Thank you for contacting the City of Sammamish regarding the current Shoreline Substantial Development Permit Application for East Lake Sammamish Trail Segment 2B (SSDP2016-00415).

Exhibit 29
SSDP2016-00415
003261

Review of Sammamish Trail Plans Near Location 457

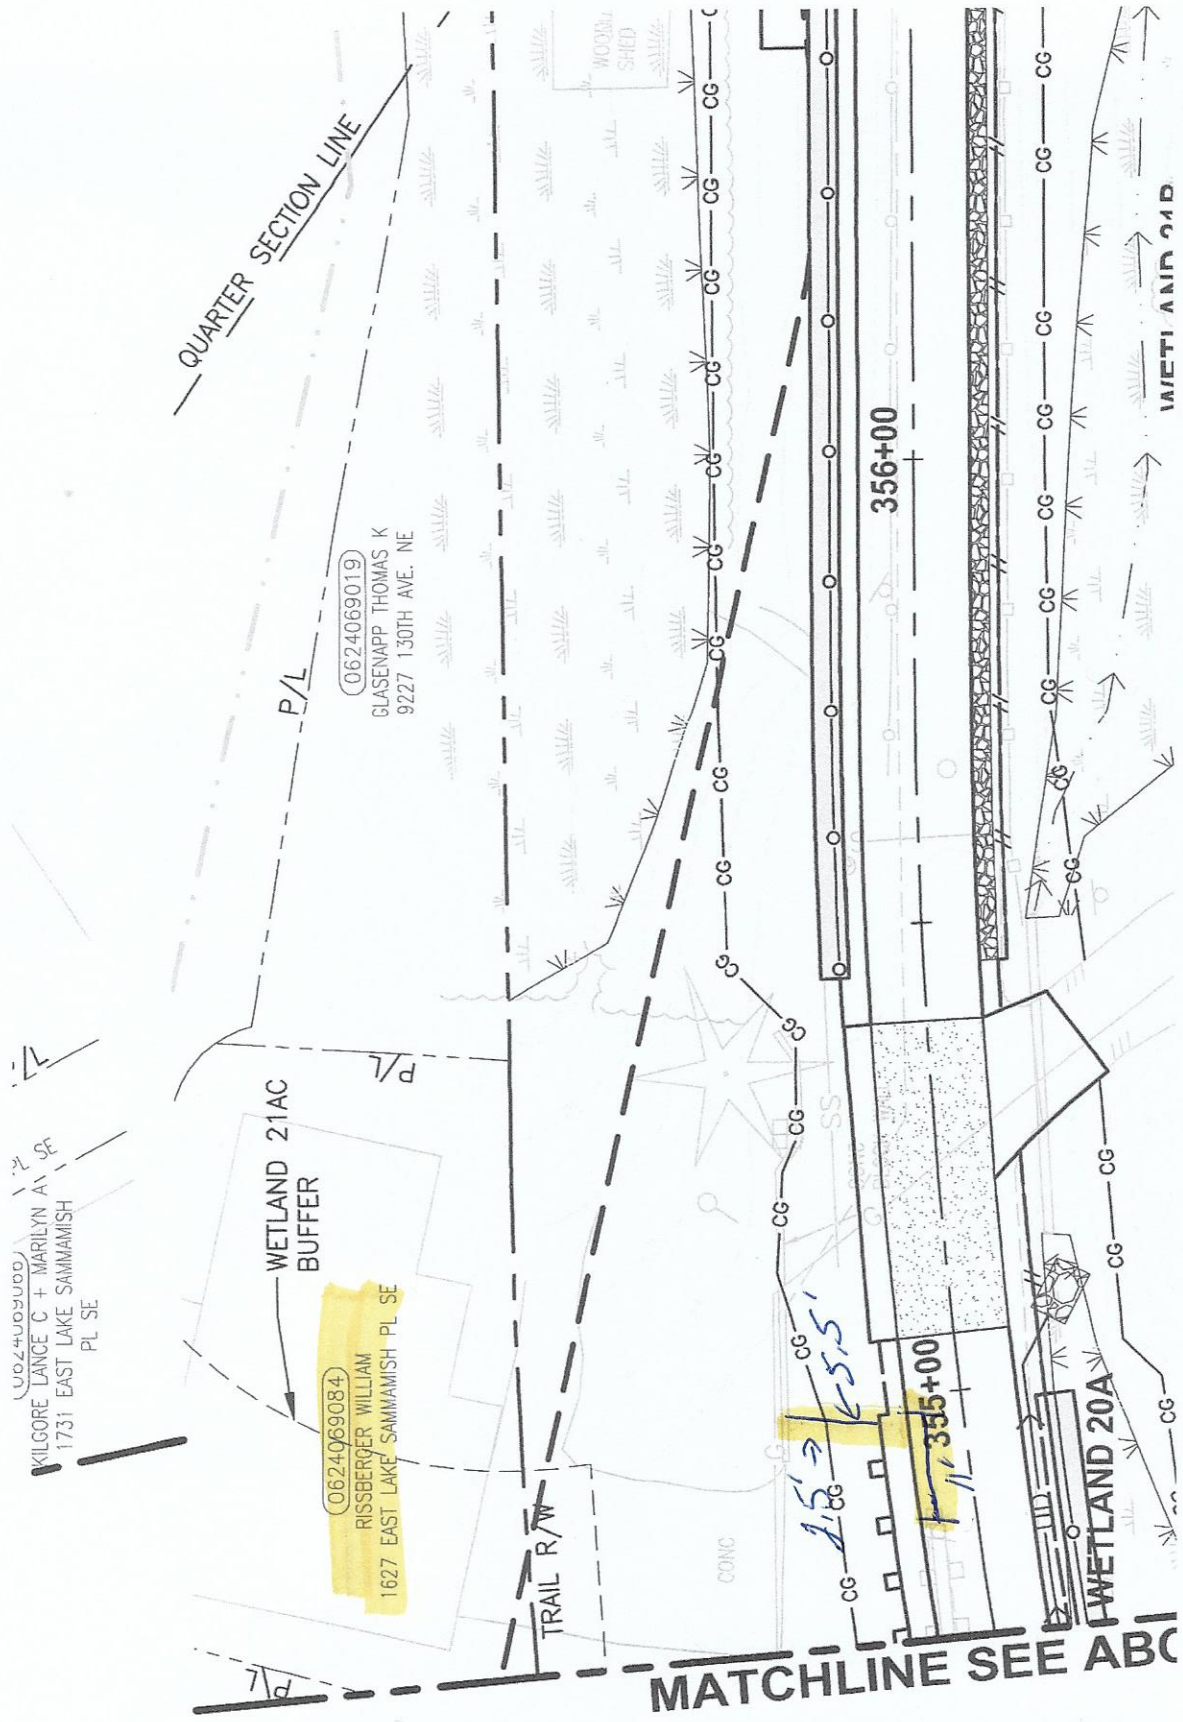
Per our meeting with Kelly Donahue, King County Department of Natural Resources, I am sending you this letter to document two unacceptable errors at location 355 in the ELST 60% build plan. They are:

Please let me know the proper steps I can take to insure these errors are corrected in the final build plan.

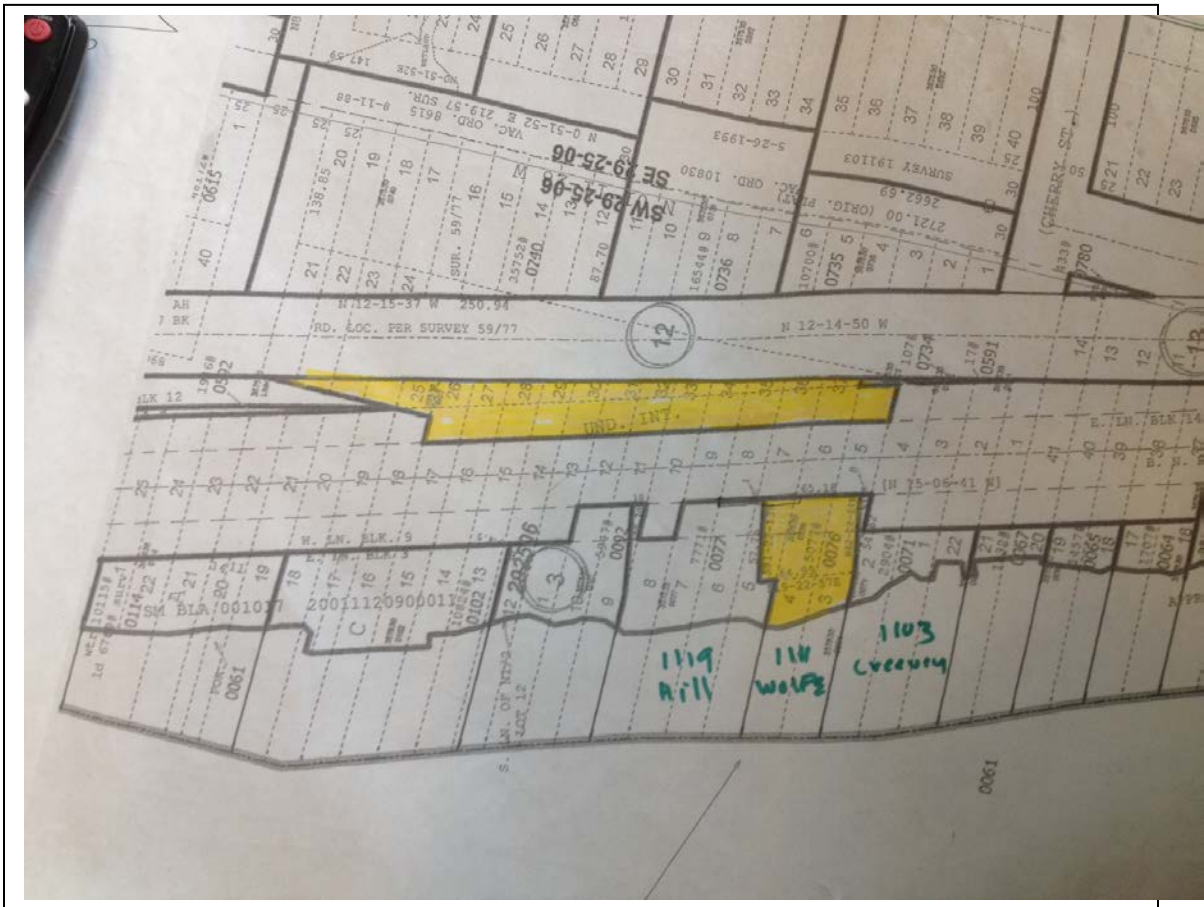
Note that the broken concrete upon which the poured foundation rests could be removed back to the 13' from centerline mark and that the structure would still be stable. This is also true for the parking area on the north side of Stair #82 which go from the parking lot to the trail. This would allow you to build a wall which starts at 10' from the centerline and which is up to 2' thick and still have room to leave my carport/shed. You could back fill from the broken concrete to the new wall. There is no need to remove the carport/shed. Keeping them where they are would not impact the trail in any way.

Item Three: Stair #82

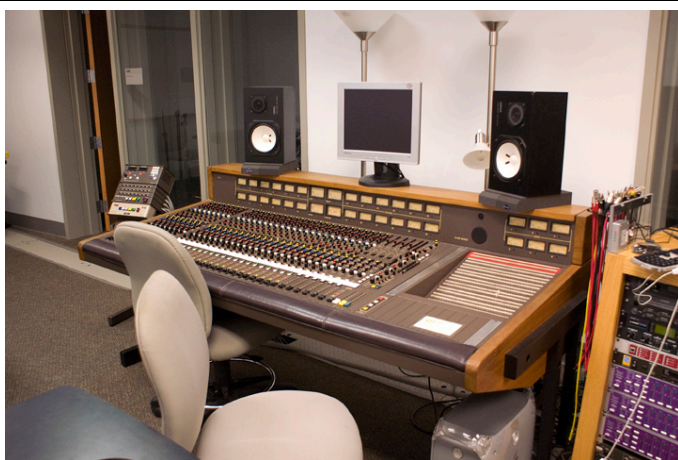
On the 60% plans the county shows the elimination of my stairway which goes from my parking lot to the trail (Stair #82) as well as designing a 90 degree turn in the new stairs from the trail to my home (Stair #81). Neither of these design decisions are necessary and both would put my business at risk.

The edge of the bottom riser on Stair #82 going from the parking lot down to the trail is more than 15 feet away from the centerline. This would leave room for at least a 3 foot landing at the bottom of the stairs and that landing would still be more than 12 away from the centerline. There is no need or reason to remove these stairs—and from the discussion above you can see that removal of these stairs would have a severe financial impact on my home business.

SB-276

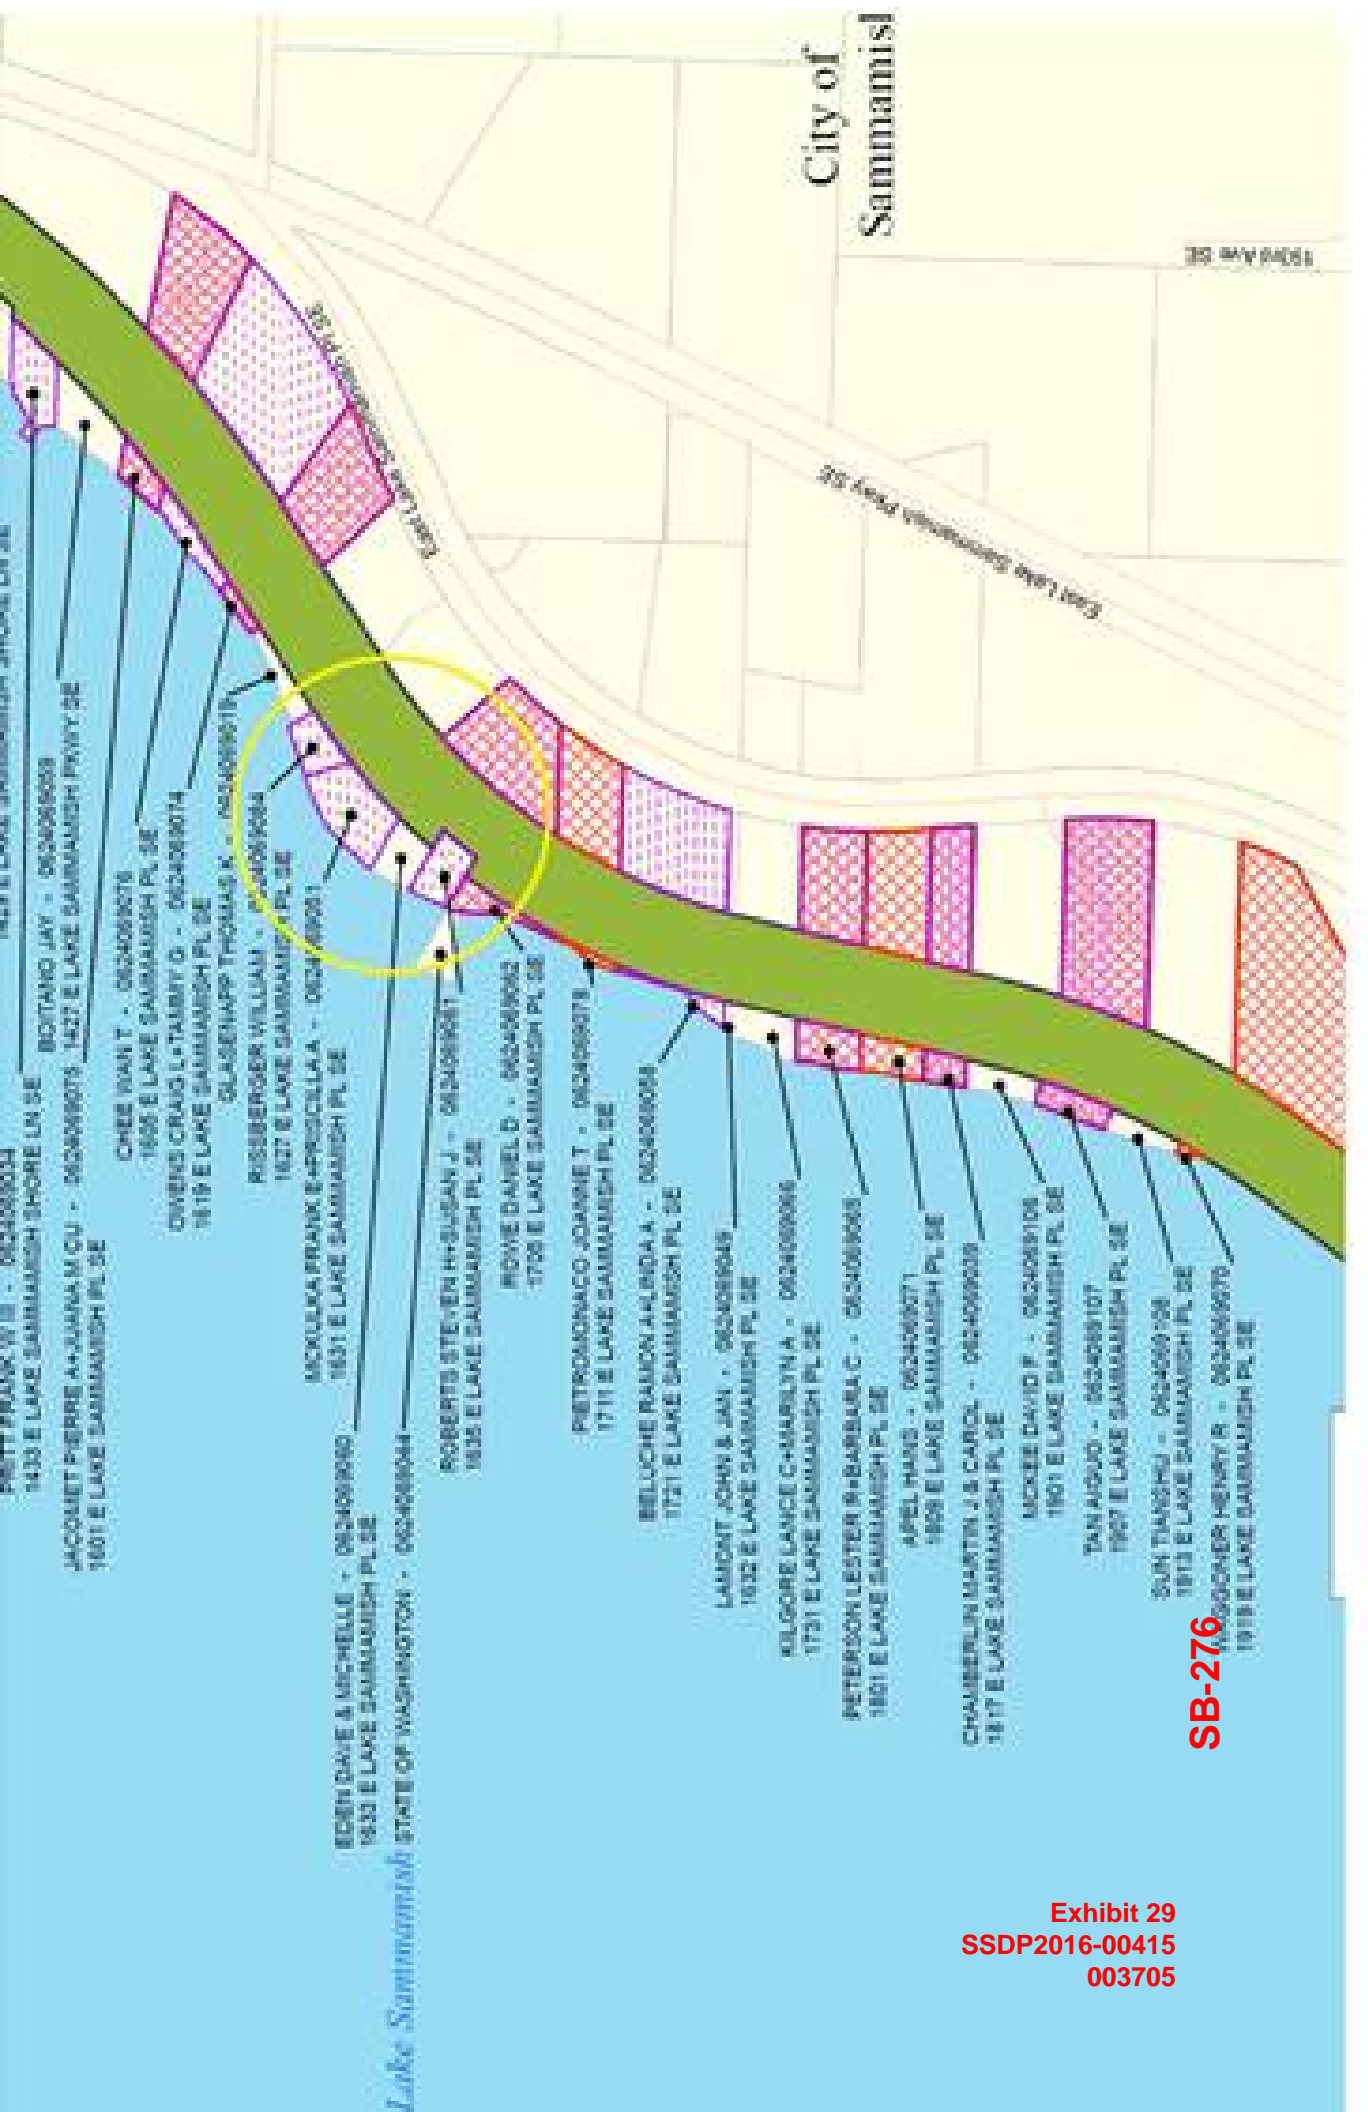
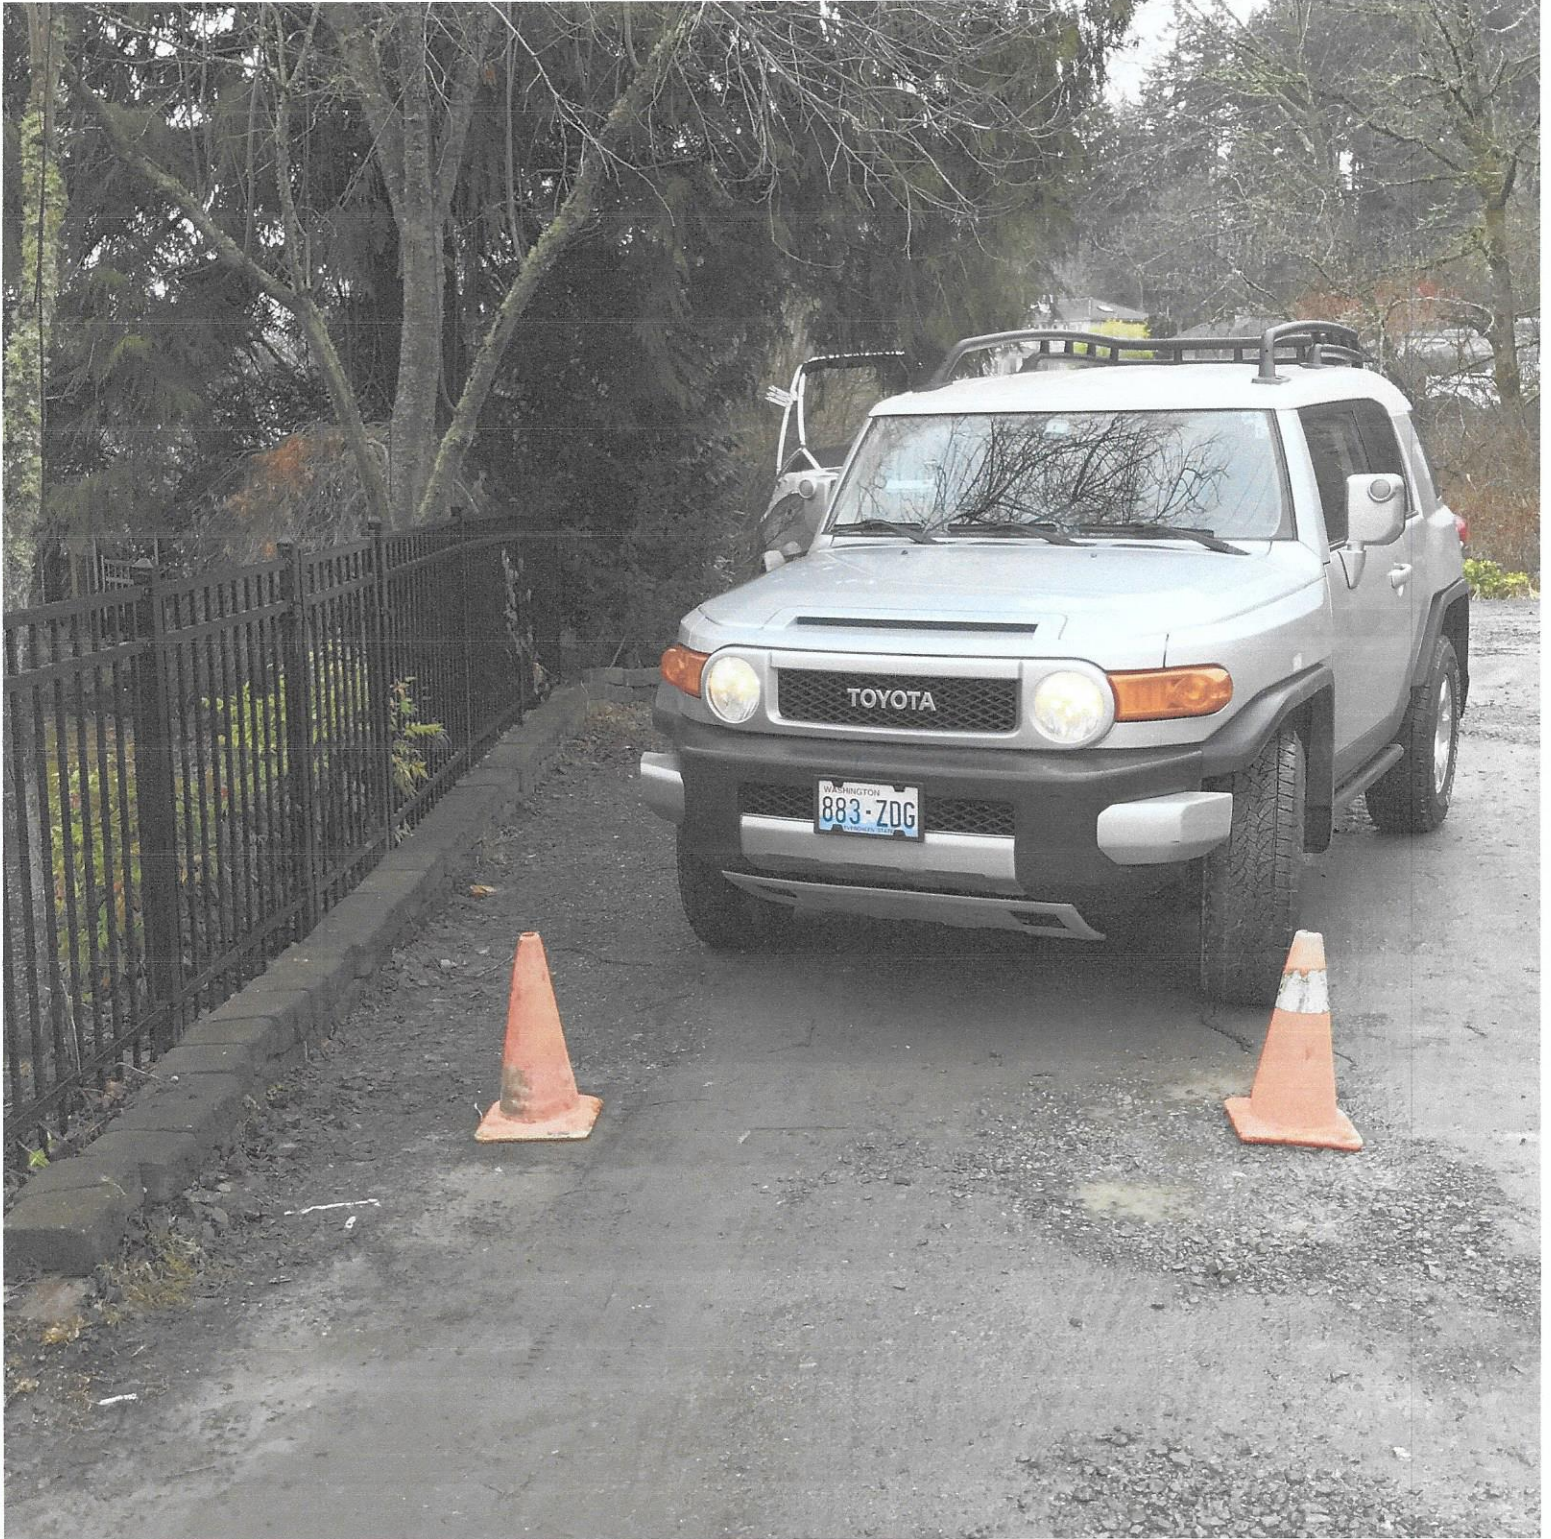
We are asking that during construction the following changes are made to the 60% plans.

-1. The CG fence line be adjusted to allow access for emergency, residential and commercial vehicles to our properties.

-2. The trail center line be moved east approximately two+ feet in sections 353 to 355 to allow for access to our properties.
